GOVERNMENT OF THE DISTRICT OF COLUMBIA
DEPARTMENT OF GENERAL SERVICES

SOLICITATION DCAM-21-CS-IFB-0001

**REDEVELOPMENT ST. ELIZABETHS EAST CAMPUS
PECAN STREET INFRASTRUCTURE IMPROVEMENTS**

AMENDMENT NO. 6

2 ADA RED TOP METER

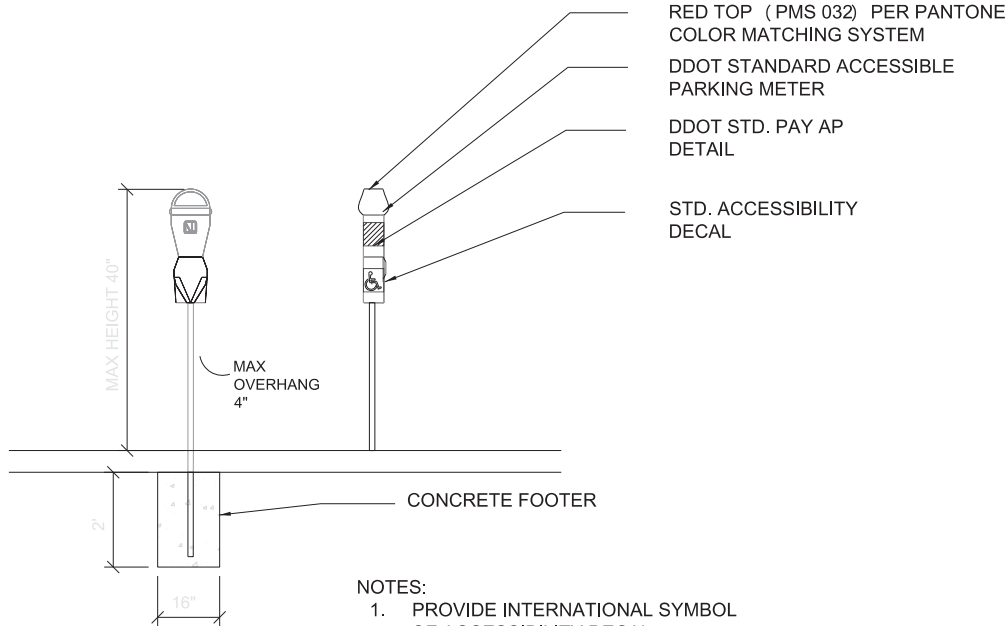
5	J.1.1	Multi-Parking Space meter, and the other is for the ADA Red top meter. Which one from these two will be used on item 608109 – Parking Kiosk with an estimated quantity of 7 each?	There are no ADA Red Top Meters in the contract. Pay item 608109 is for the multi-parking space meters only. Disregard detail 2 on sheet L-0408B in J.1.1
6	J.1.1 and J.2	The estimated quantity for item 205003 - structure excavation is 160 LF. This quantity approximately matches the length of the steam tunnel to be removed at Pecan St. What pay item covers the removal of the steam tunnel at the temporary staging area? See attached drawing for more details.	There is no pay item length needed for steam tunnel removal in the temporary staging area. See revised Sheets DM-1, DM-2 and GN-2 indicating no steam tunnel demolition is required within the temporary staging area. Replace these sheets in attachment J.1.1. No change is needed in J.2 bid form.
